CLARIFICATION REGISTER: **TNPA/2025/05/0010/95183/RFP**: CONSTRUCTION OF THE MARINE WORKS FOR THE UPGRADE OF BREAKWATER (NEW DOLOSSES) PROJECT AT THE PORT OF RICHARDS BAY

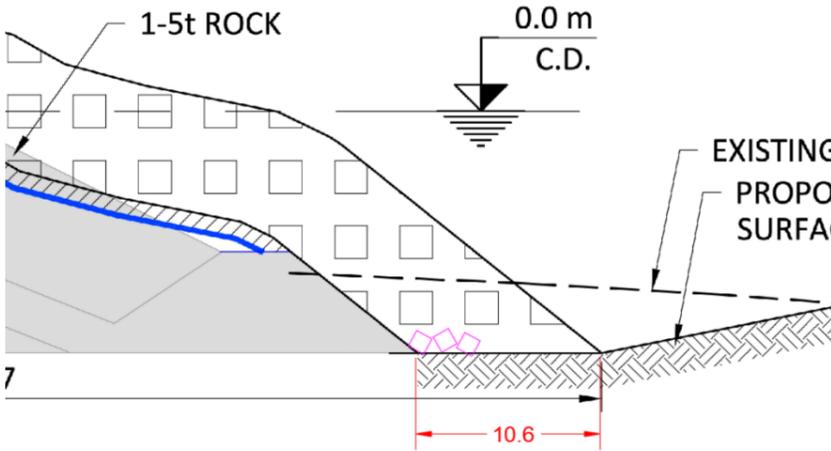
| 14. |             | 3.1.38 The Contractor complies with   | <p>With reference to RFP Section 3.1.38 in Page 307, could the Employer provide safe areas for the parking of Contractor's construction vessels/equipment in case of severe storm weather for the Contractor to select?</p>  |           | Contractor's land-based equipment can be parked in contractor's yard.  |

|     |  | the following constraints in the execution of the <i>Works</i> : |  |  | Bidders can use the Naval island slipway ( 28°47'54.74"S, 32° 4'51.51"E) to park construction vessels during severe storm weather   |

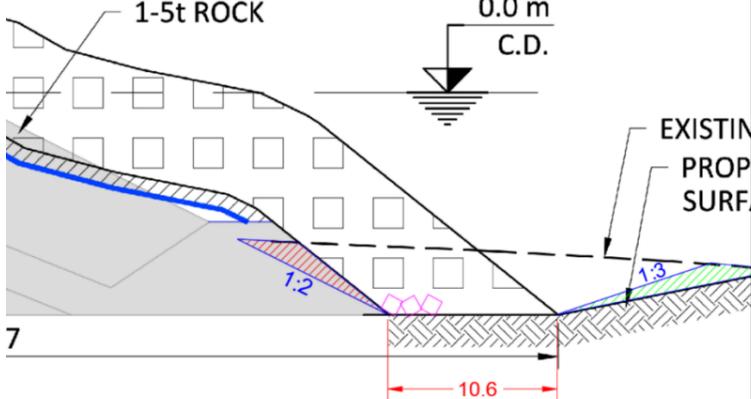
| <p>24.</p> | <p>26-Nov-25</p>                          | <p>DREDGING PARTICULAR TECHNICAL SPECIFICATION and PART C2: PRICING DATA</p>   | <p>The specification anticipates that refusal may be reached while dredging, which will then determine the end of dredging in a particular area. It is critical to ensure alignment on what constitutes refusal. Will a minimum pump capacity and configuration (e.g. minimum jetting-water power) be specified and is there an operating method specified that ensures that the pump is upright while engaging the seabed? Once all the agreed parameters are achieved in the field, will refusal be defined as the point where progress slows below a certain predefined value?</p> | <p>2 &amp; 8 Dec-25</p> | <p>No minimum pump capacity, configuration or operating method is specified.</p> <p>A trench extending more than 10 m seaward relative to the original design section is required. It is considered unlikely that any obstructions will be encountered at this point. Dredging down to the required level at this point should therefore be possible for all sections. Dredging can then proceed towards the toe of the original design profile.</p> <p>Refusal is defined as the point at which dredging operations are prevented by exposing an area of hard material /rubble that is too extensive to be lowered by dredging along its edges. Typically, this is not expected to extend to the seaward edge of the trench where dredging down to the required level should be possible. Once exposed, such an area must be surveyed and submitted to TNPA to decide how to proceed. The survey should clearly show the deepest area dredged along the seaward edge and the exposed rubble area. The level difference between these two surfaces needs to be considered in potentially modifying the proposed toe and Antifer placement grid. The image below indicates the size of 3 t rock (average rock size) as purple squares relative to typical dredge sections.</p> |

|     |  |   |  <p>Essentially, dredging the toe trench will reveal where the actual position of the breakwater toe is (which may differ from the design position). The design intent is to place toe Antifers at the actual toe level just seaward of the toe. Exposing the toe will require dredging the sand down to the top of the toe as well as determining the seaward extent and bottom level of the toe by dredging down to this point. When the Contractor has reached a point where he believes the seaward bottom point of the rock toe has been defined, a survey should be submitted for evaluation. Some additional dredging may be required along the toe line to confirm that it does represent the actual toe line. Payment for such dredging will be in terms of the normal dredging rate.</p> <p>In the unlikely event that the actual toe extends further seaward than the design toe, a design adjustment will be made to avoid placing Antifer units beyond the crane reach.</p> |
